Application Number: 10/824,915  
Filing Date: April 15, 2004  
Appellant(s): SELLE, STEPHEN

**EXAMINER'S ANSWER**

► Claims 1 and 3-11 stand rejected under 35 U.S.C. 103(a) as being obvious over Applicant's admission of prior art, in view of either Selle US-6,640,968 or Liestner US-6,209,722.

Examiner's reasonably broad interpretation of Bursk et al. US-4,352,258.

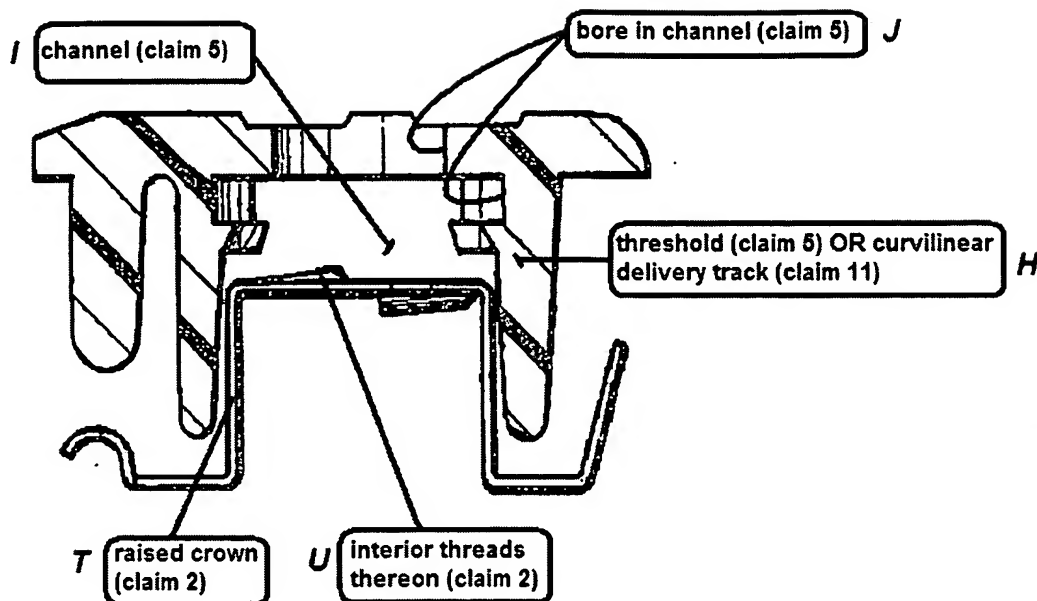
In response to Applicant's argument that the examiner has not shown the bounds or the extent of the channel is irrelevant. Applicant merely claims a (broad) "channel", and gives no such limitation to the "bounds or extent of the channel". In order for Bursk et al. to anticipate claim 5, Bursk et al. must show a channel (I) in a threshold (H), said channel (I) having a bore (J) therein. Examiner has clearly demonstrated that Bursk et al. discloses these limitations.

Applicant's argument that the rectangularly-shaped nut taught by Bursk et al. is not constrained against rotation by the channel of the threshold is not persuasive. Threshold (H) has a channel (I), in which at least the raised crown (T) and interior threads (U) of the rectangularly-shaped nut (B) reside in. Since the nut (B) is rectangularly shaped and has two faces held against rails of threshold (H) forming the channel (I), it is held in non-rotatable fashion in said channel (I).

Examiner's reasonably broad interpretation of Bursk et al. US-4,352,258.

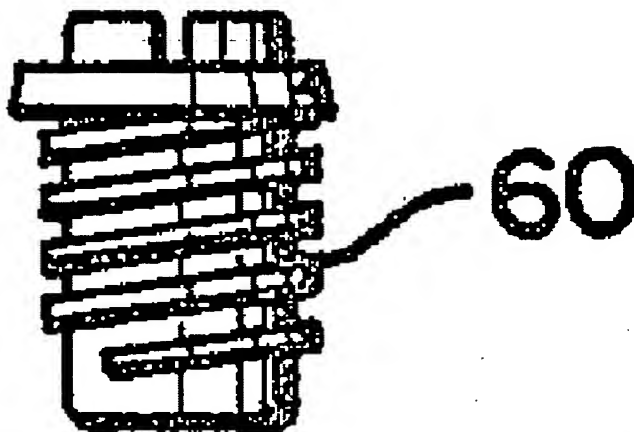
Examiner acknowledges Applicant's statement that in the Bursk et al. reference, "it appears that screw 60 does have a flat head and is adjustable in a plurality of positions" (emphasis added). Claim 7 of the instant application states: "A threshold adjustment device....wherein said threaded stud includes a flat head and is adjustable in a plurality of positions". Therefore, it appears that Applicant is in agreement with the examiner that the Bursk et al. reference anticipates at least those limitations found in claim 7.

Examiner's reasonably broad interpretation of Selle US-5,993,320.

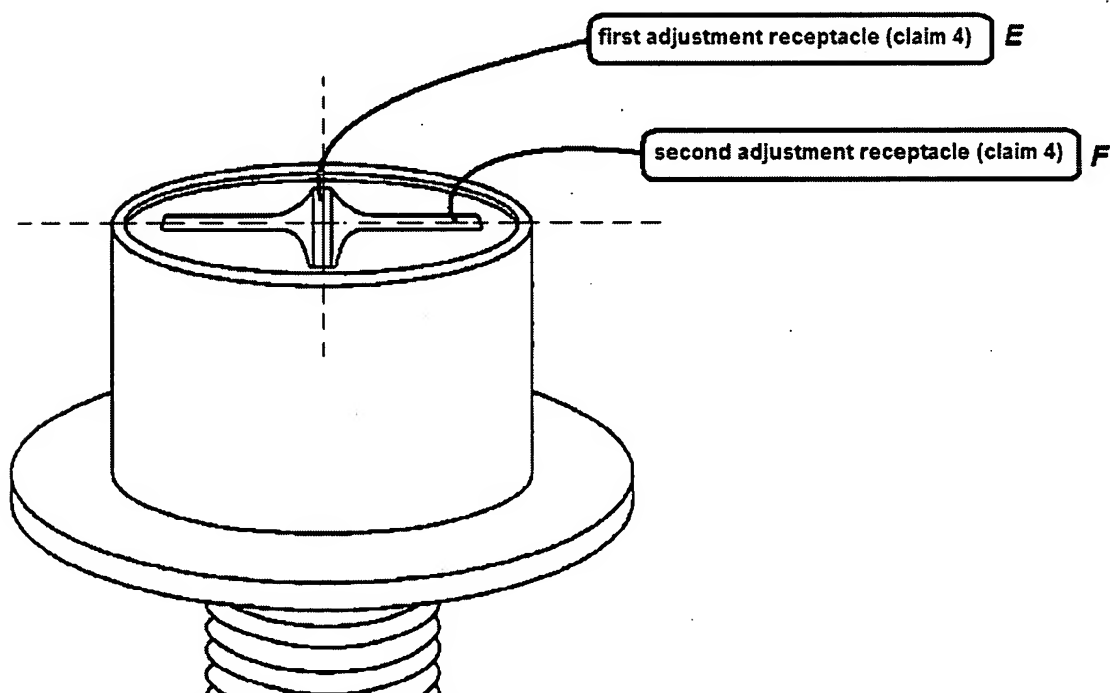
As indicated in the above rejection, Examiner disagrees with Applicant that Selle fails to include a head guide and a flange guide. It was stated to Applicant in the final rejection mailed on 31 October 2005 that the examiner has interpreted claim 11 as not positively reciting the "fastener", "threaded stud", "support head", "U-shaped nuts", and "rearward and forward flanges". However, claim 11 does positively recite "a curvilinear delivery track", "a head guide",

and "a flange guide -- all of which are taught by Selle US-5,993,320 (see below drawing). The preamble of claim 11 states that the intended use of the curvilinear delivery track is "for delivering a plurality of fasteners..." and then goes on to recite certain structural features of said fasteners, and how they would interact with the curvilinear delivery track when "said head guides of said delivery track engage said support heads of said fasteners" and when "said support heads of said fasteners [are] in combination with said head guide". Examiner acknowledges Applicant's statement that "the claim lacks a positive recitation of the threaded stud having support head is correct".

Examiner's reasonably broad interpretation of Mettler US-6,185,870

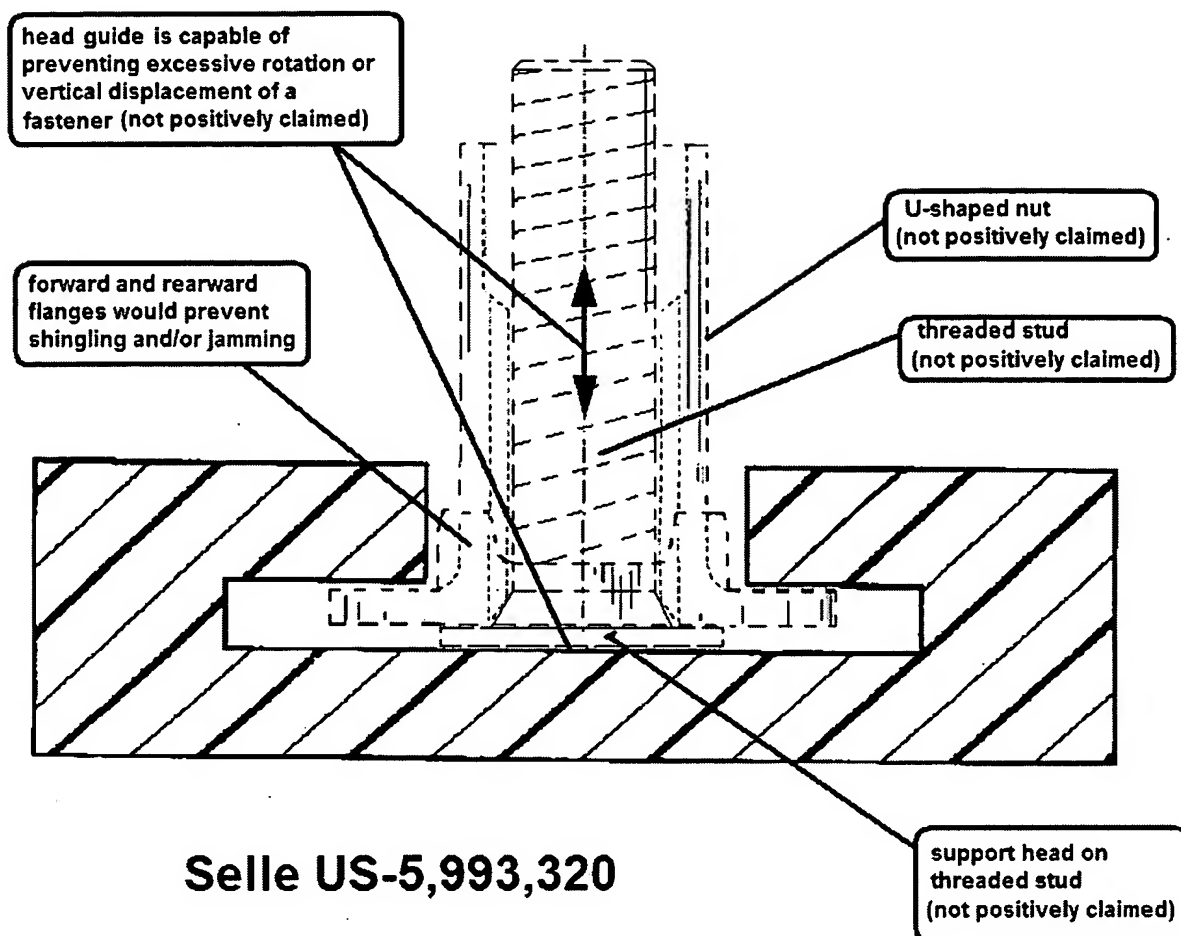
Applicant's argument that Mettler US-6,185,870 does not include two adjustment receptacles as claimed is not persuasive. Mettler clearly shows two adjustment receptacles (E) and (F). The purpose for providing a second adjustment receptacle is to allow both a flat head screwdriver, AND a Phillips head screwdriver to adjust the threaded stud.
